HOMEWOOD HISTORIC DISTRICT DESIGN GUIDELINES

**Prepared for the Minneapolis Heritage Preservation Commission
City of Minneapolis
Community Planning & Economic Development (CPED)
~~July~~November, 2016**

Figure #7. Building on multiple lots

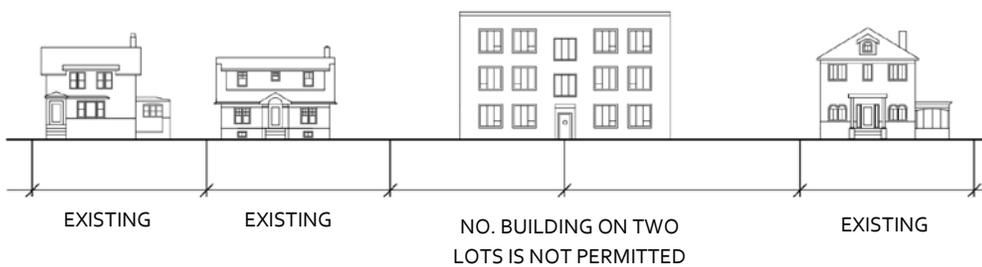
Comment [SJ76]: BRADLEY COMMENT 4 – Permit combinations of all lots except R1 zoned lots.

Comment [JKS77]: PICKLE COMMENT 25 - Page 22: "Combining lots is not permitted. Building a single structure on two lots is not permitted." What is the rationale for this given the very large lots with single structures on the western side of the district? It appears that single homes on larger-sized lots was common an appropriate for the period and location.

STAFF RESPONSE – Text deleted to address this.

STAFF RESPONSE – Text deleted to address this.

Figure #11. Garage roof pitch and design complement the main structure

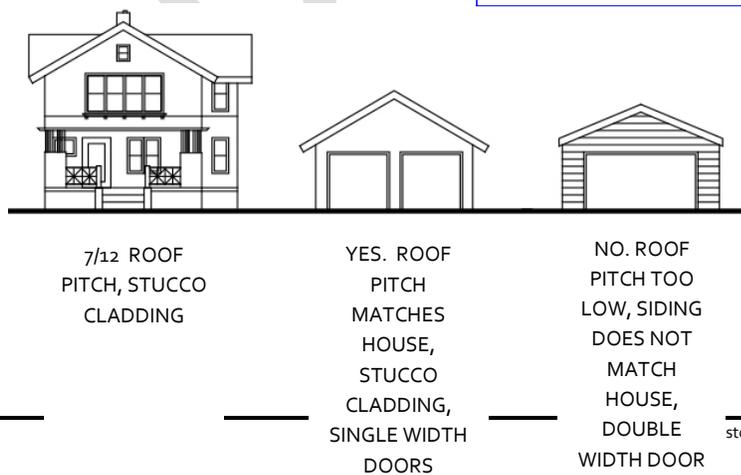
Comment [JKS87]: BROPHY COMMENT 50 – Change text to read, “The roof pitch shall be consistent with the primary roof pitch of the design of the main residence ~~and or~~ surrounding garage roof pitches (See Figure #11).” This article says most detached garages are low pitch. Houses are higher pitch. A new garage can't be consistent with both. Fig 11 is wrong.

Comment [SJ92]: BROPHY COMMENT 54 - Fig 11 new garage does not fit. Page 25A says “Most detached garages ... are ... low-pitched. Double width garage doors are the dominant type.

STAFF RESPONSE – Text amended to provide greater flexibility for homeowners and figure 11 deleted.

STAFF RESPONSE – Figure deleted.
